TECHNICAL NOTE:

Envireau Water (2017) 'Hydrogeological Risk Assessment, Markwells Wood Site, Forestside, West Sussex'

(Appendix 9.1A to UK Oil & Gas (UKOG) Environmental
Statement Addendum made under South Downs National Park
planning application SDNP/16/04679/CM)

Document reference: MW/HGRA_Crit/310317FINAL

Technical Note Figure 1. Map of dry valleys (as depicted by Head deposits), Clay-with-Flints deposits and monitoring boreholes in the vicinity of the UKOG site at Markwells Wood. Showing also potential surface karst features determined from LiDAR data (incomplete coverage). Scale ~ 1:18,000.

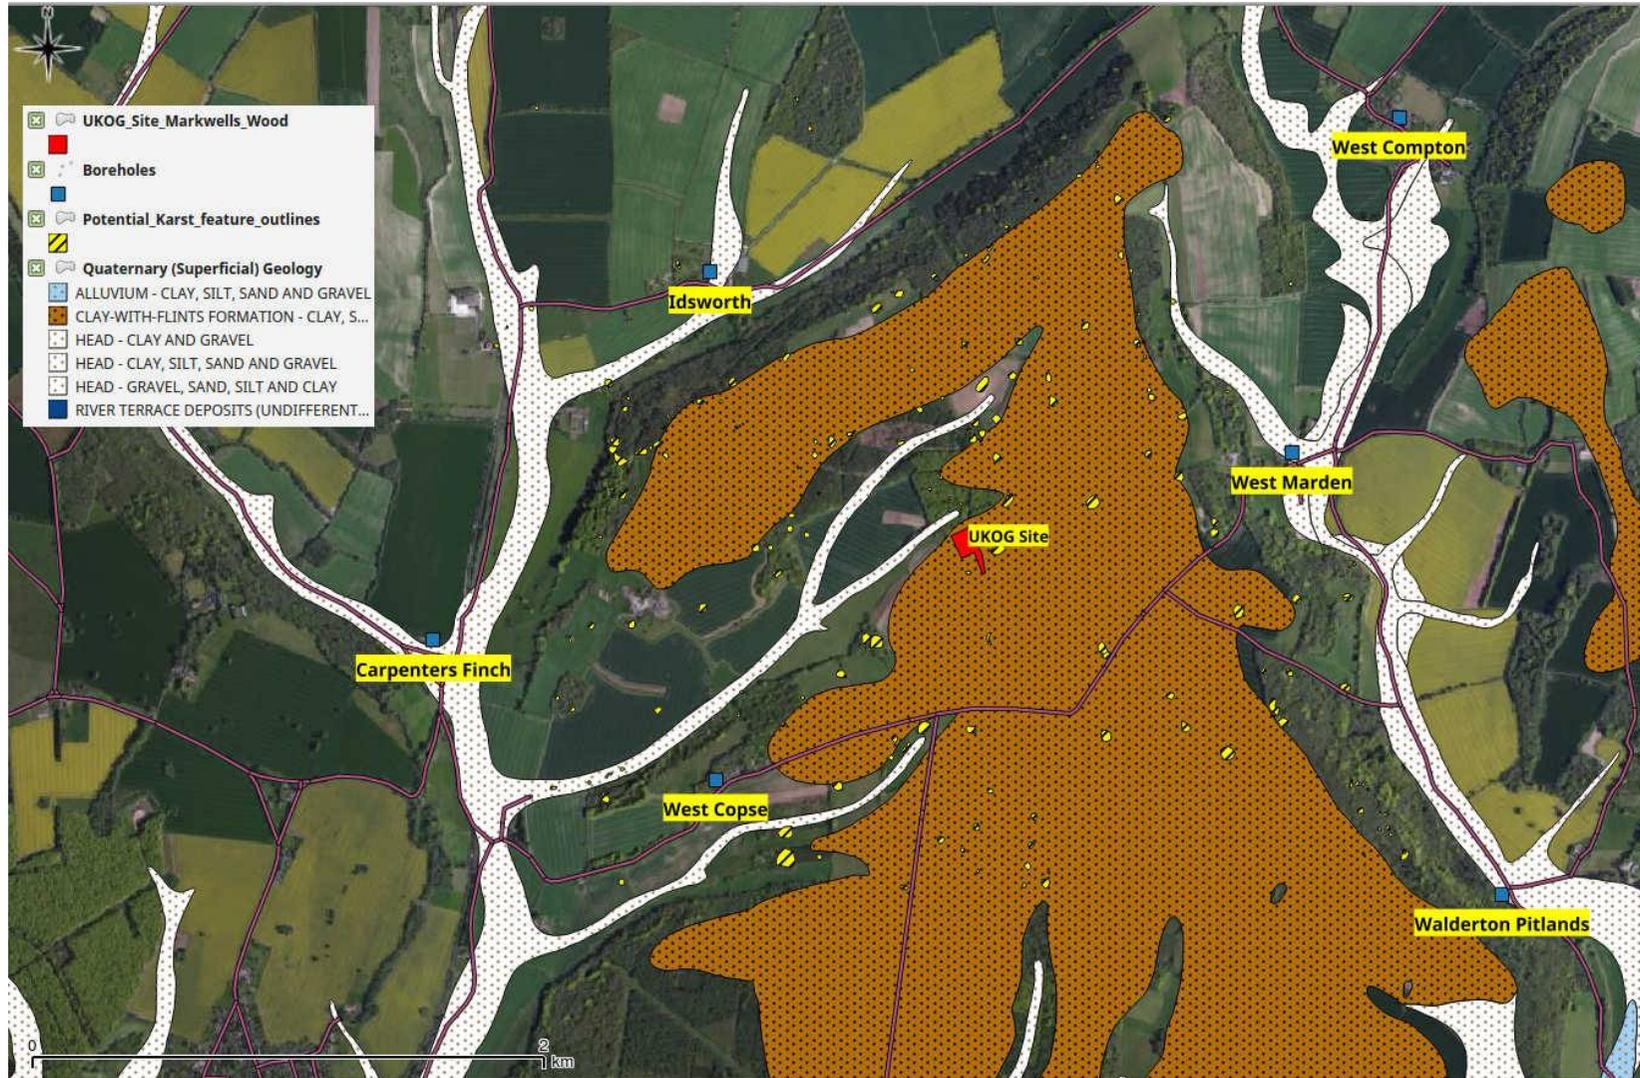
From the outset (e.g. Figure 1a) Envireau Water (2017) insist that the UKOG site at Markwells Wood is located on an interfluvium, and that the only dry valleys of importance to an assessment of hydrogeological risk are the two principal Havant and Emms dry valleys. This is simply not the case. The interfluvium between the Havant and Emms dry valleys is dissected by numerous other dry valleys tributary to the Havant and Emms valleys. The UKOG site itself is located immediately adjacent (<50 m) to the base of a minor dry valley and as such is much closer to the dry valley than to the centre of the interfluvium.

Closer inspection, however, reveals that the Wood Copse Forest borehole is situated on almost the exact centre of a small interfluve between two dry valleys (see Technical Note Figure 1). It is therefore unsurprising that this borehole, being the most closely situated to the centre of an interfluve, exhibits the lowest range of seasonal groundwater variation.

With respect to the aerial photography and LiDAR data presented on Figures 8 & 9, this may be compared directly with the LiDAR assessment presented in EGG Consultants Ltd (2017), the results of which are also shown on Technical Note Figure 1. It appears that the majority of potential karst solution features in the wider Markwells Wood area have not been recorded by the Envireau Water study.

This is completely incorrect. Please see Technical Note Figure 1 and EGG Consultants Ltd (2017).
